## canopy

Design Review, Type III Application  
LU 15-209365 DZM, AD  
September 15, 2015 Revision | ZGF Architects, LLP

# Applicant Response to DAR Summary

## East Elevation

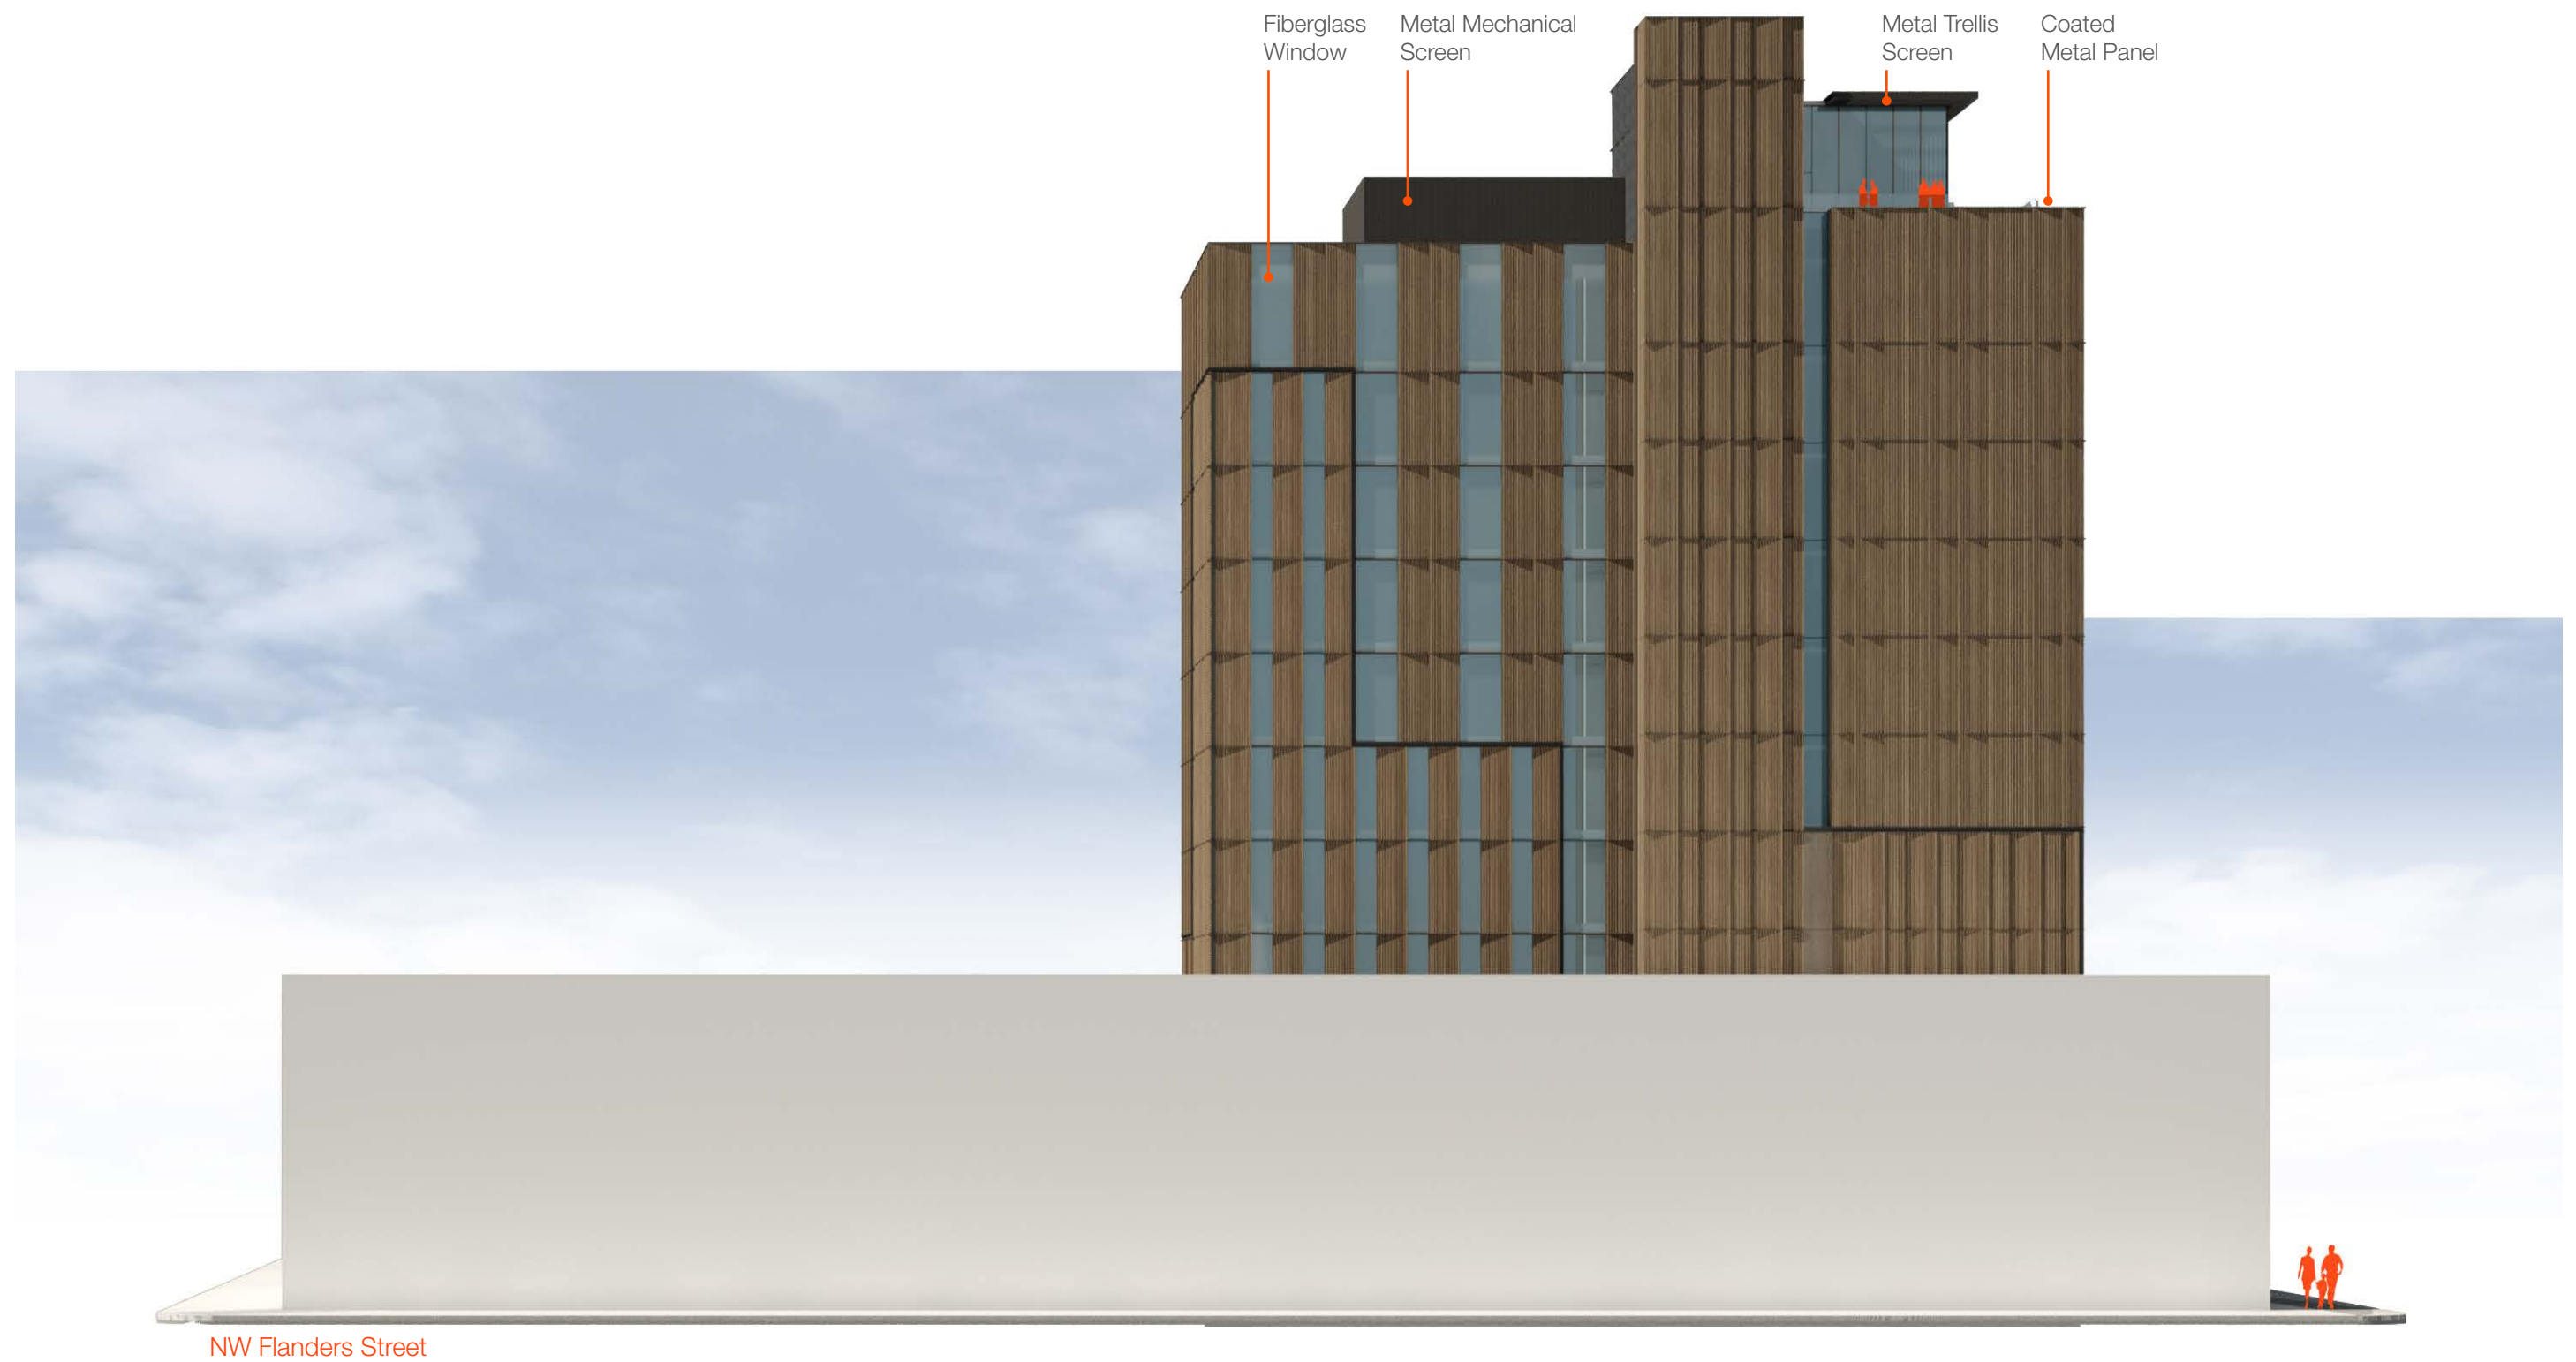
5. *Show signs in the elevations and renderings and with more detail if Desitng Review is required.*

5. *Add additional canopies that project over the public rights-of-way for weather protection as required in the applicable Design Guidelines.*

The two sign locations were reviewed in the DAR and are shown on Exterior Elevations within this document. Both signs are less than the maximum 30 sf size thus not reviewed under Design Review. Additional detail will be submitted with the permit set.

Canopies have been added on the north and east elevations. See EXHIBIT 29

**Ground Floor Plan | 1/16" = 1'-0"**

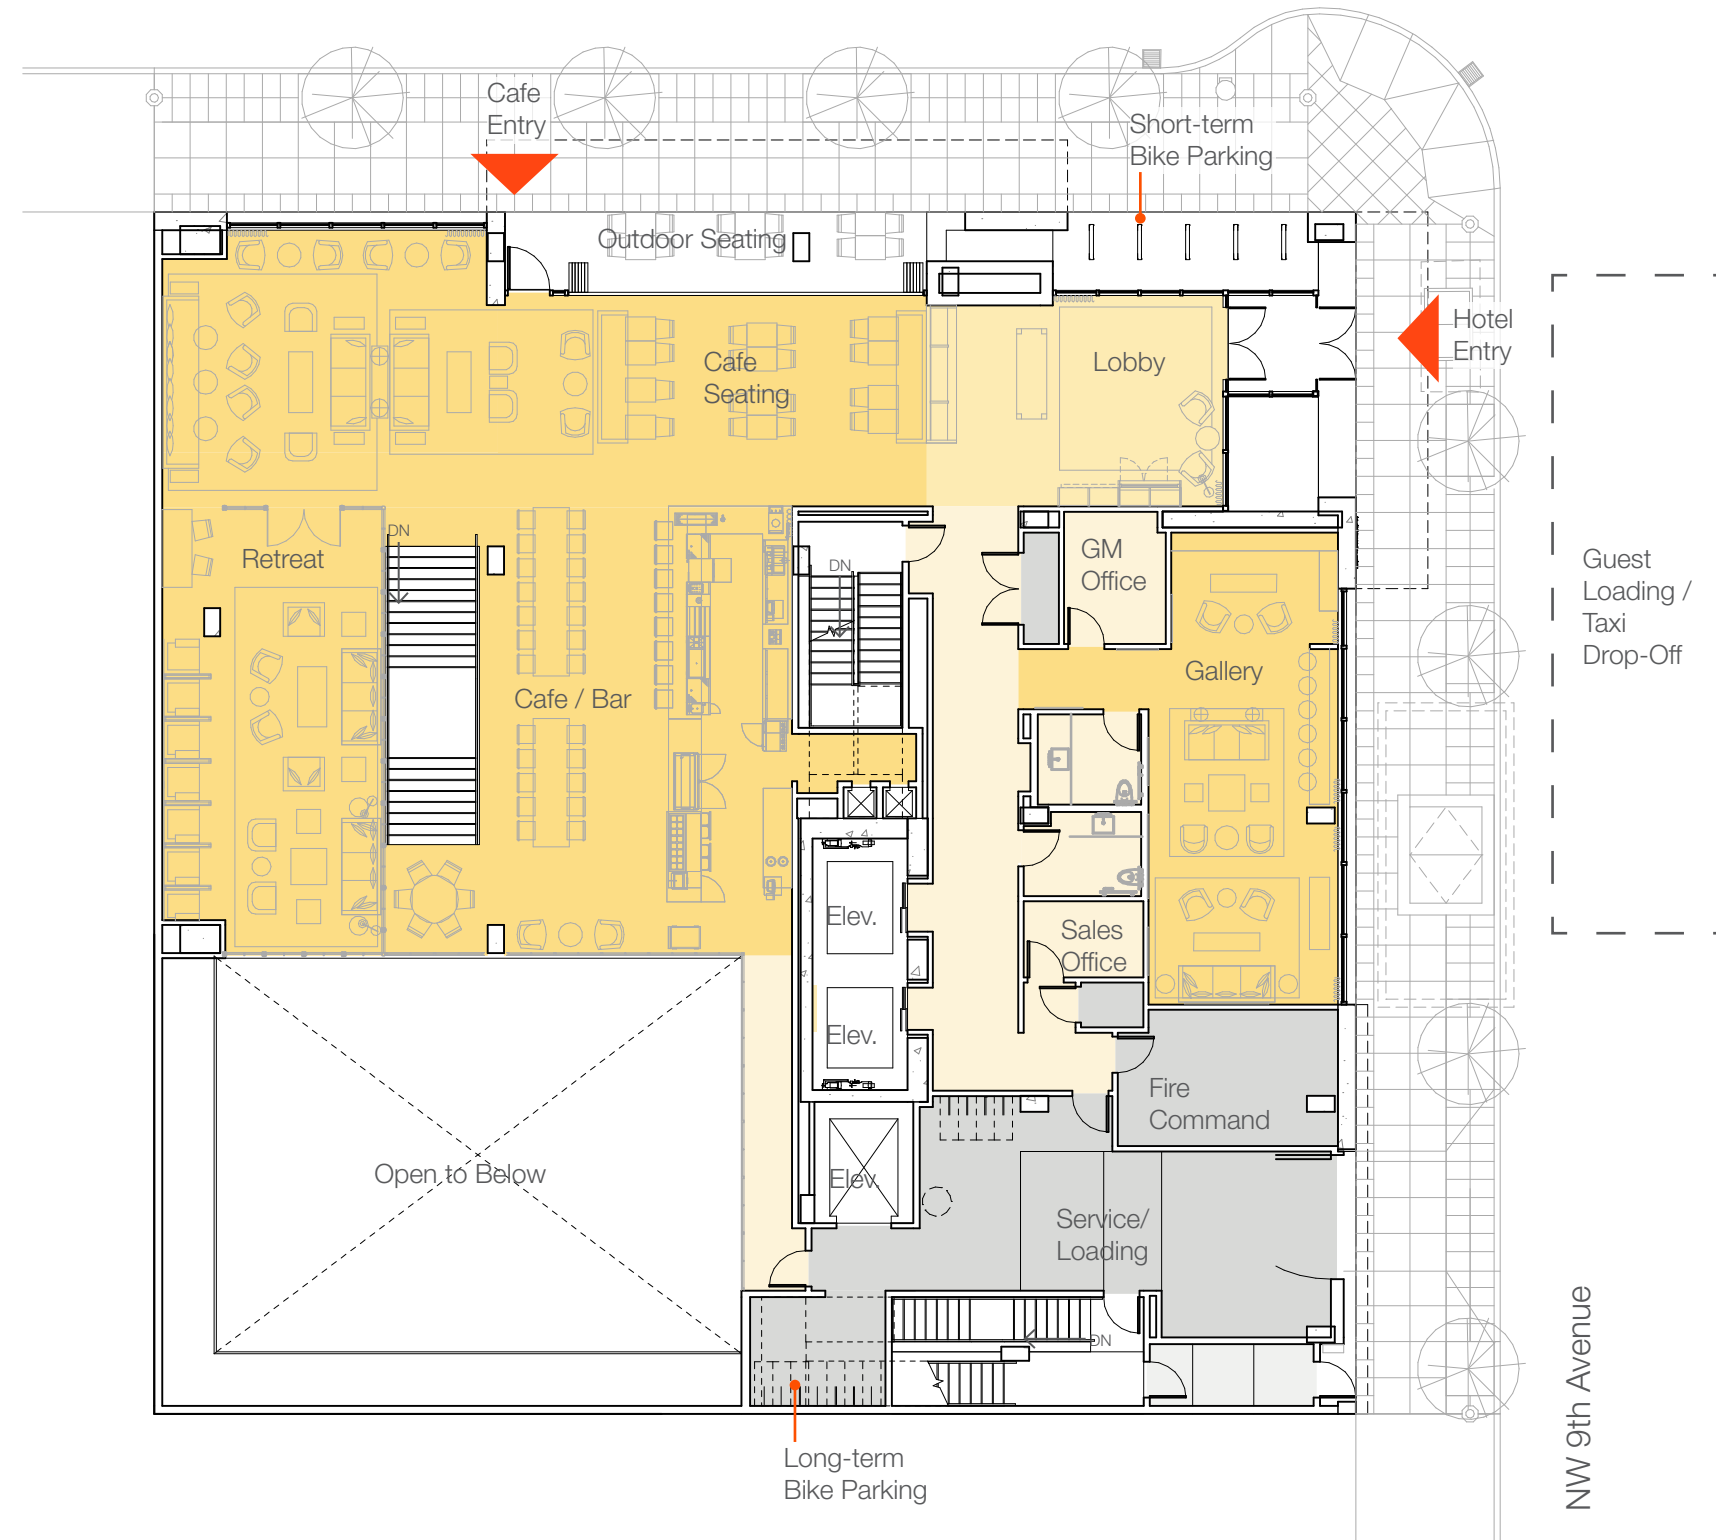
3. *Explain the valet parking operations and show the drop-off area and stand on the plans.*

The site plan EXHIBIT 56 shows the proposed taxi and valet zone along 9th Avenue adjacent the primary entrance to the hotel. A parking management plan will be put in place for this location. The hotel operator is considering an off-site location at City Center Parking located at NW 11th and Davis to handle any vehicles (letter was attached to Adjustment Request) to operate valet parking for the hotel 24 hours a day. In addition, the hotel will also consider providing a 24 hours Valet Parking Manager to manage pick-up and drop-off operations, including taxi drivers, in front of the hotel as well as coordinating drop-off and retrieval of vehicles from off-site parking. A valet stand would be located adjacent the main entry under cover of the entrance canopy. The operator recognizes these operations will be critical to the hotel and the surrounding uses to ensure expedient flow of hotel guests coming and going and to minimize disruptions to traffic flow. It is also understood that the site is located within a high-quality transportation network, with excellent access to local and regional roadways, both rail and bus transit, quality bicycle connections and pedestrian accommodations. Hotel operations plans to take advantage of the transportation network surrounding the site.

**Enlarged Plan | 1/4" = 1'-0"**

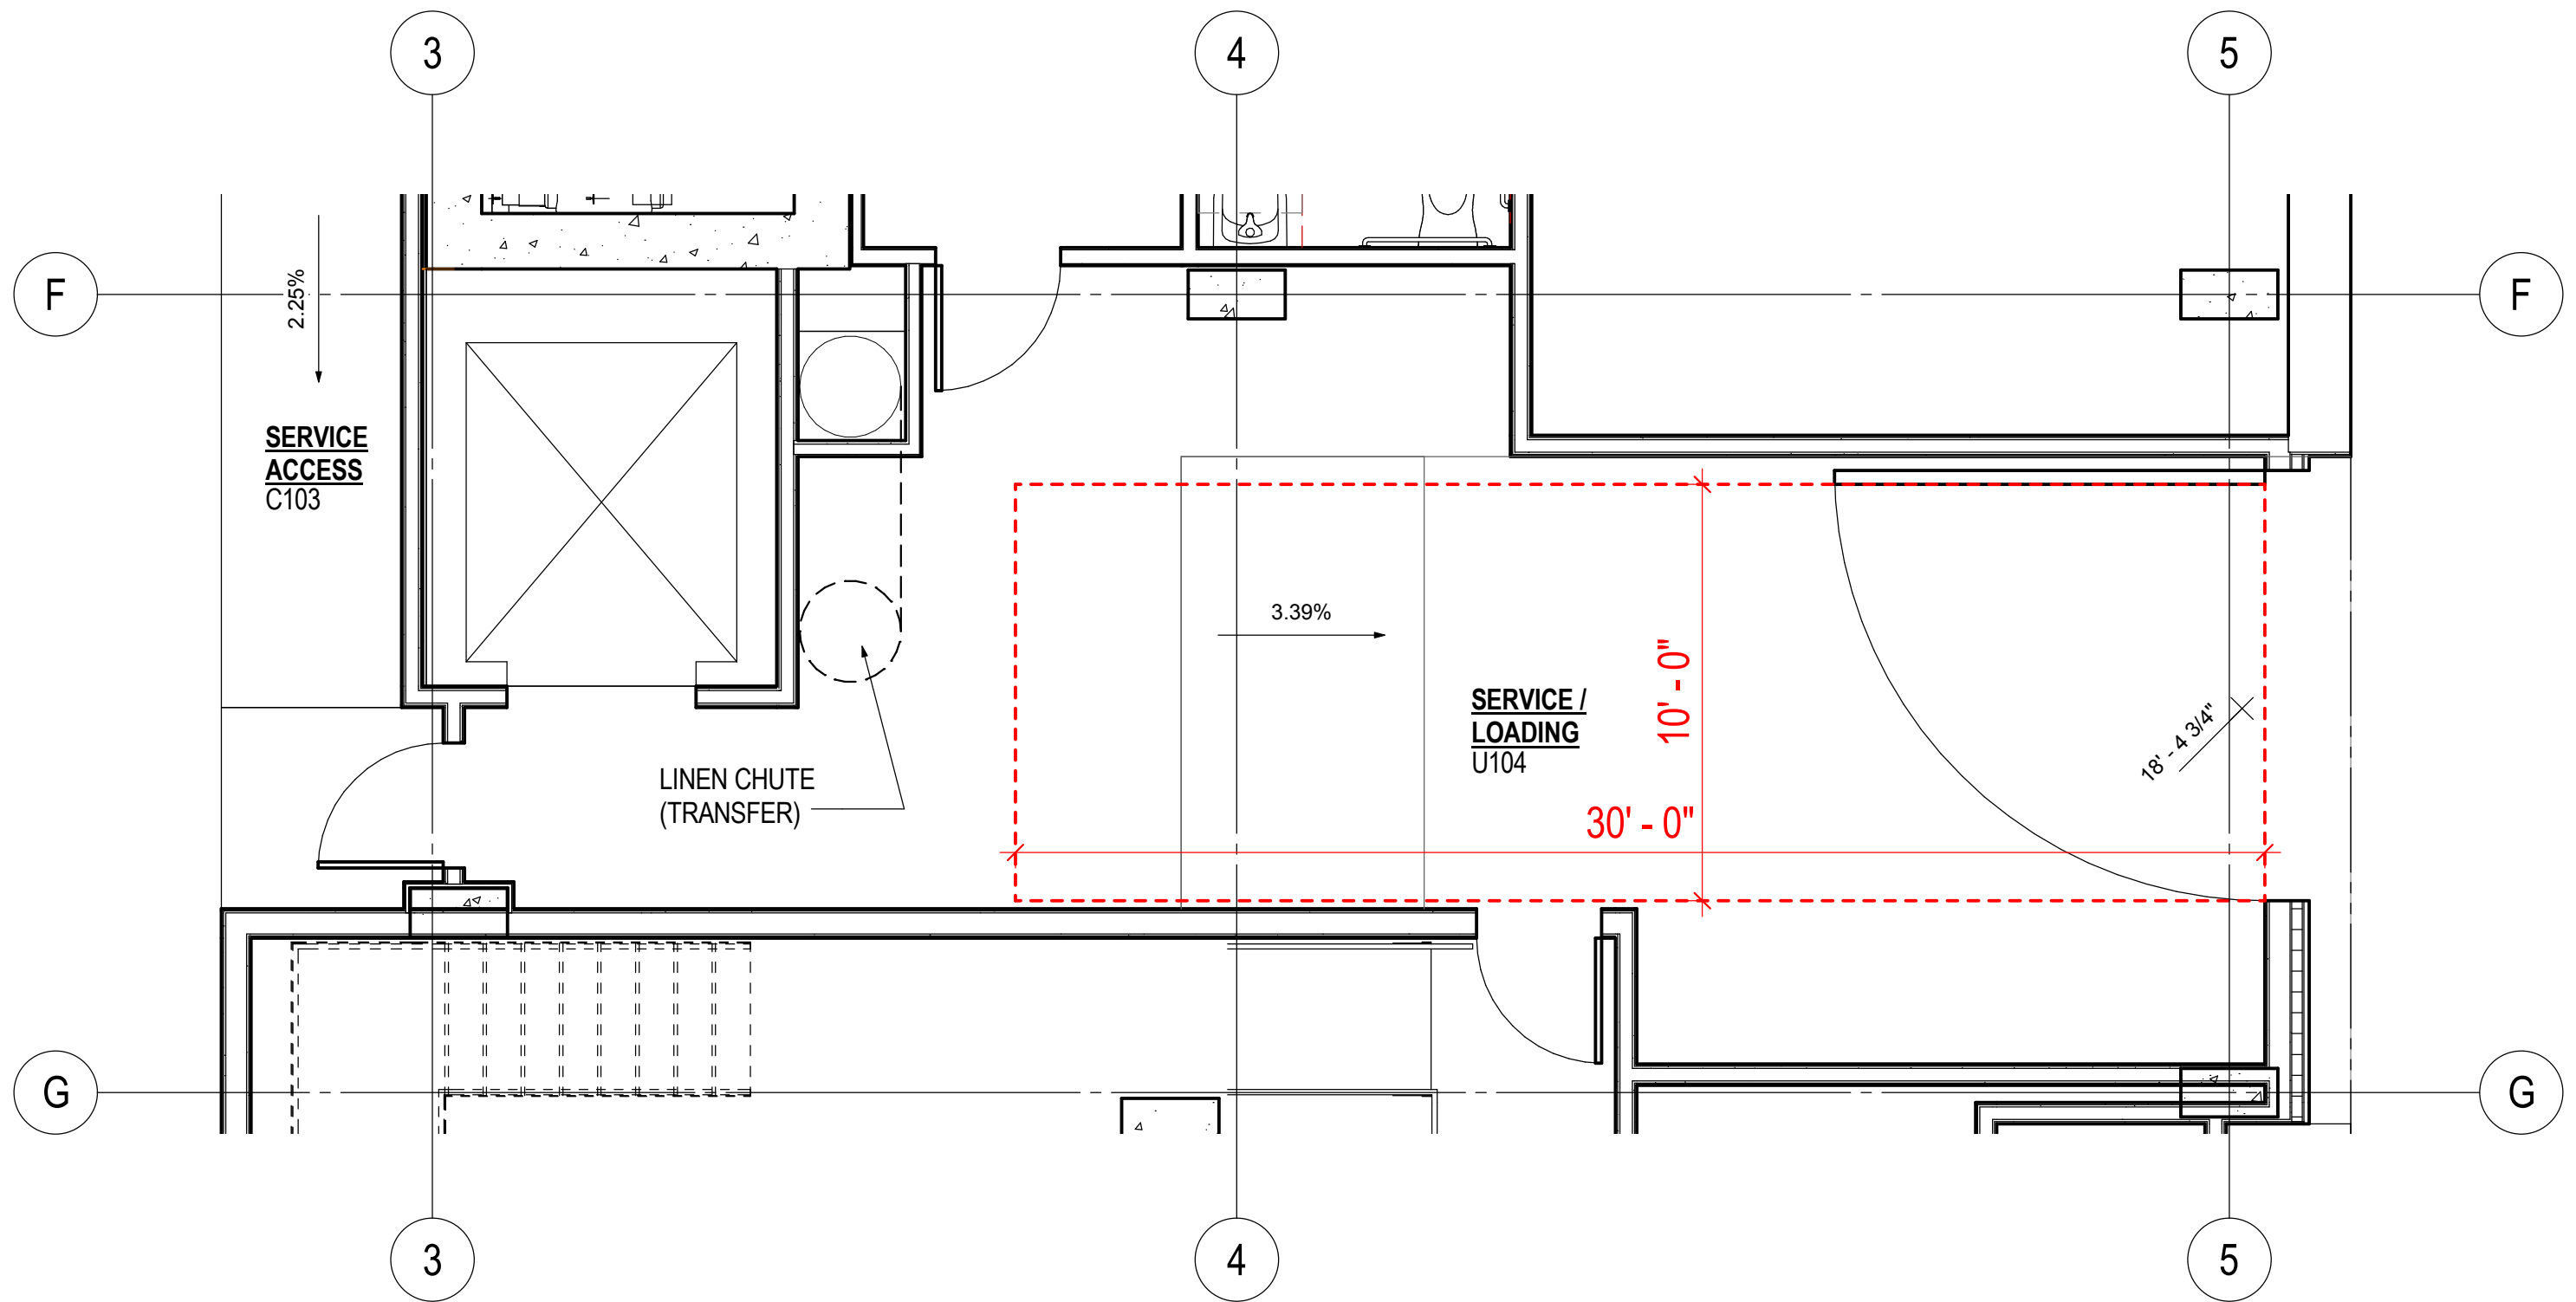
We request reduction of the required depth from 35 feet to 30 feet. The assumed purpose of an on-site loading provision is to provide an alternate to on-street loading. Vehicles anticipated for use in delivery or loading of goods are generally 24’ long and will easily fit within the service/loading bay. In requesting this modification, the applicant does not intend to change the service bay from the current physical configuration. All walls and doors will remain in the same position. The applicant simply requests a reduction in the space designated for spatial clearance and the act of loading and unloading. A 24 foot long truck may park in the physical space with 1 or 2 feet of clearance at the head to allow the service door to close fully. This leaves 3 or 4 feet of ‘designated space’ at the tail end for loading/unloading. The additional 5 feet not designated as loading can then be utilized for other program, such as staging of a laundry cart.
